ECE/TRANS/WP.29/GRE/2008/27  
11 July 2008

**REGULATION No. 37**  
**(Filament lamps)**

**Proposal for Supplement 33 to the 03 series of amendments to Regulation No. 37**

**Submitted by the expert from India \*/**

Insert a new sheet WY10W/1, between sheet W5W/1 and sheet W15/5W/1 to 3, to read (see next pages).

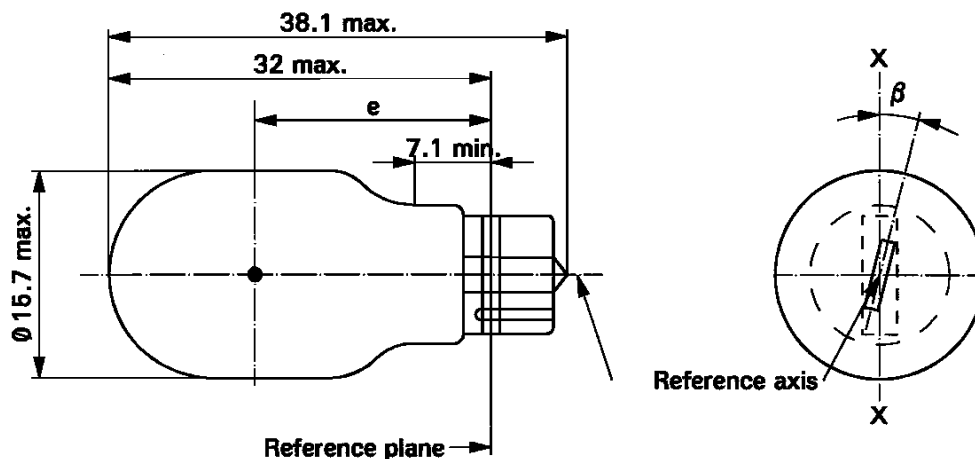
Dimensions in mm		Filament lamps of normal production			Standard filament lamp
		min.	nom.	max.	
e		18.3	20.6	22.9	20.6 ± 0.3
Lateral deviation	<u>1/</u>			1.0	0.5 max.
$\beta$		-15°	0°	+ 15°	0° ± 5°
Cap W3x9.5d – As per the attached drawing. (To be added in IEC Publication 60061)					
<b>ELECTRICAL AND PHOTOMETRIC CHARACTERISTICS</b>					
Rated values	Volts	12			12
	Watts	10			10
Test voltage	Volts	13.5			13.5
Objective values	Watts	11 max.			11 max.
	Luminous flux	75 ± 20 %			
Reference luminous flux at approximately 13.5 V:		White: 125 lm			
		Amber: 75 lm	280 lm

Insert a new sheet WY16W /1, between sheet W16W/1 and sheet W21W/1 to 2, to read:

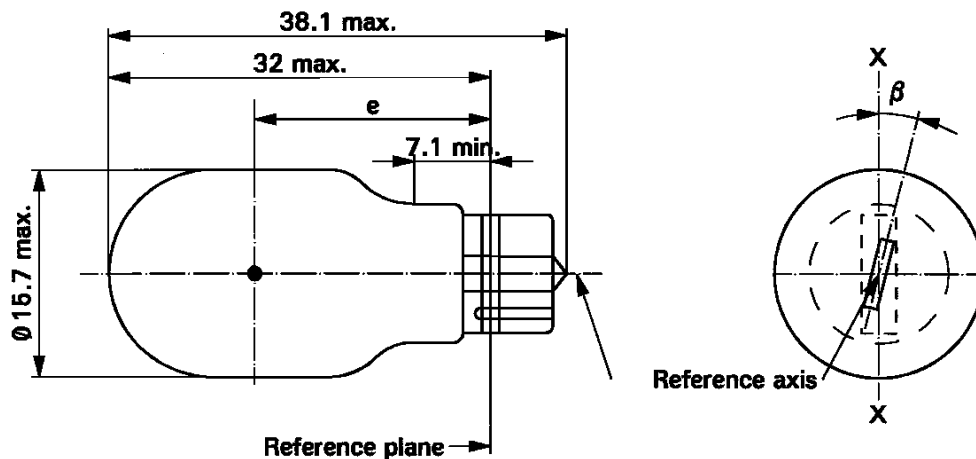
Dimensions in mm	Filament lamps of normal production			Standard filament lamp
	min.	nom.	max.	
E	18.3	20.6	22.9	20.6 ± 0.3
Lateral deviation <u>1/</u>			1.0	0.5 max.
β	-15°	0°	+ 15°	0° ± 5°
Cap W3x9.5d – As per the attached drawing. (To be added in IEC Publication 60061)				
<b>ELECTRICAL AND PHOTOMETRIC CHARACTERISTICS</b>				
Rated values	Volts	12		12
	Watts	16		10
Test voltage	Volts	13.5		13.5
Objective values	Watts	21.35 max.		21.35 max.
	Luminous flux	189 ± 20 %		
Reference luminous flux at approximately 13.5 V:	White:	310 lm		
	Amber:	189 lm	280 lm
